Response to Referees and Reviewers

Manuscript egusphere-2025-3573 "The Estimation of Path Integrated Attenuation for the EarthCARE Cloud Profiling Radar"

1 Referee Comments (RC2):

Figure 1: PIA uncertainty Look-up-table created using mean of absolute differences of residuals. The solid black contour delineates the transition boundary beyond which the model-driven method yields lower PIA uncertainty.

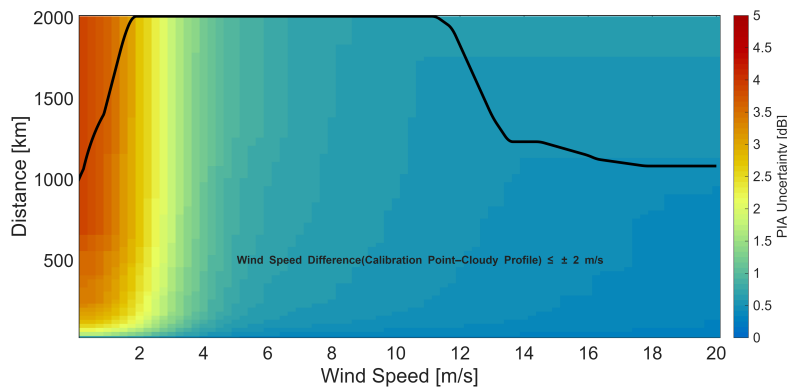
- 1) Compute the difference using only five calibration points (as is done in the algorithm) selected randomly, and produce multiple realizations of each difference.
- 2) For each wind speed and distance bin, estimate the uncertainty by using the absolute value of the differences in that bin and taking the expected value or mean of those absolute differences. Since the PIA uncertainty has direct influence on the uncertainties in hydrometeor retrievals, it is important that the NRCS uncertainty be estimated accurately. I'd like to see a more rigorous estimate of NRCS uncertainty used in the article.

Following your suggestion, I also constructed a LUT using the mean of the absolute differences instead of the standard deviation. This approach resulted in a underestimation of the uncertainty enabling interpolation over larger distances. I am attaching the LUT generated (Fig.(1)) using this method for your reference.

Figure 2: PIA uncertainty as a function of wind speed at the cloudy profile for different separation distances between calibration and cloudy points.

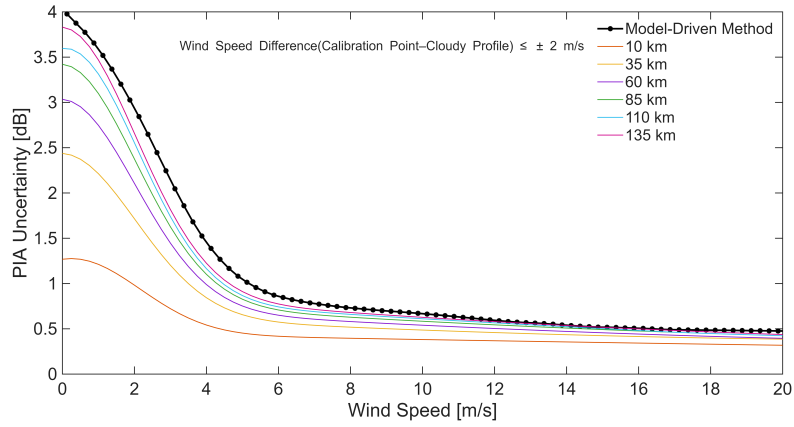
I think both of these issues would contribute to substantially underestimating the uncertainty. I am skeptical that the uncertainties in estimated PIA could actually be as small as 0.25 to 0.5 dB when the calibration points are 100 to 200 km away.

Regarding the concern about unrealistically low uncertainties when calibration points are located 100–200 km away, I would like to clarify that the uncertainty is highly dependent on wind speed. For calibration points within 100 km, the uncertainty is approximately 0.8

dB at higher wind speeds (8–15 m/s) and increases to about 1–3.5 dB at lower wind speeds (4–0.5 m/s). Refer Fig.(2) for clarification.

Figure 3: Differences in PIA estimates obtained using 5 calibration points, compared to those derived using 10 and 15 calibration points.

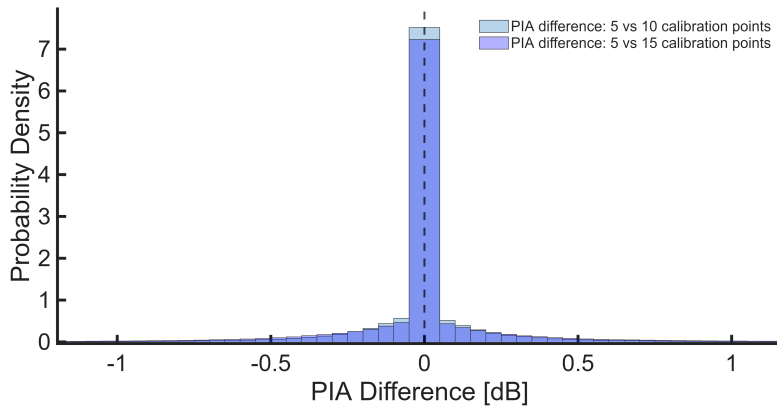
3. L106: In what way has $N=5$ been tested and determined to be "optimal"? I will see if Section 2.3 sheds light on this.

We selected $N = 5$ based on practical considerations. Calibration points are determined following the criteria described in Section 2.3: at least six clear profiles must be present within a 10 km along-track segment, the standard deviation of the measured NRCS must be less than 0.3 dB, and the calibration NRCS is defined as the mean NRCS of those clear profiles. When selecting five calibration points, we maintain a 10 km separation between each, ensuring that no two points fall within the same 10 km segment used for NRCS averaging. Consequently, when the cloudy region is adjacent to a continuous clear-sky area, the farthest calibration point is located approximately 50 km away. We also tested configurations using 5, 10, and 15 calibration points, and the resulting differences in PIA estimates were marginal (Mean of 0 dB and standard deviation of 0.05 dB), using five calibration points provided a good balance between accuracy and computational efficiency, and was therefore selected as optimal. The corresponding Fig.(3) is attached for reference.

Figure 4: Global distribution of the clear profiles and ice-cloud-only fraction within each $1^\circ \times 1^\circ$ grid cell.

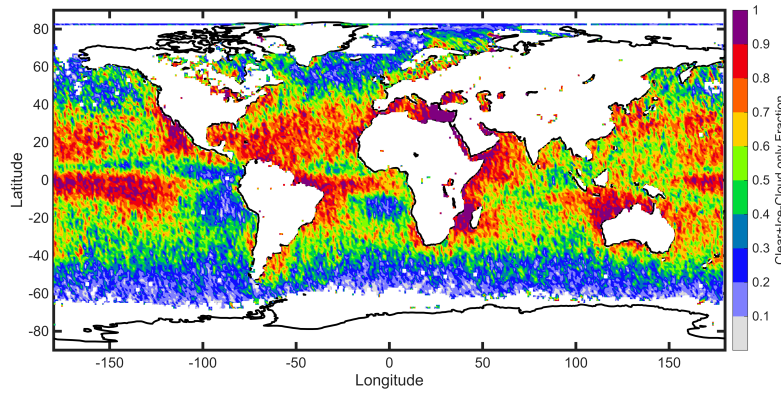
10. L222-L226 and Figure 3, caption: Per Figure 3, there are broad areas of the midlatitude storm tracks, subtropics and tropics where calibration point fraction (CPF) is 0.7 or larger. Per the definition, the CPF is the "ratio of valid calibration points to the total number of radar profiles within each 1-deg x 1-deg grid cell". My understanding, then, is that 70 or more of the observed radar profiles in these regions are valid calibration points, which are clear profiles. That seems like a very large clear fraction. If my understanding isn't correct, some additional explanation is needed in the text.

Thanks for the comment. To clarify, the calibration point fraction (CPF) shown in Figure 3 (refer the manuscript) represents the six-month mean fraction of profiles within each 1-deg x 1-deg grid cell that satisfy the calibration point criteria described in Section 2.3 (which will be better explained in the revised manuscript). Therefore it is an average number. If we compute the "clear-sky plus ice-cloud only" fraction from the EarthCARE CPR data it can indeed reach values as high as 70% in the tropical regions in the sinking branches of the Hadley cell (Fig.4). The clear-sky and ice-cloud only profiles are identified using significant detection mask in EarthCARE and to identify ice-clouds, a cloud base temperature of less than $-263.15K$ is imposed. Of course this value would be reduced when considering other observations that include visible and infrared radiation (thus more sensitive to thinner clouds) like in (Leah Bertrand and de Boer, 2023).
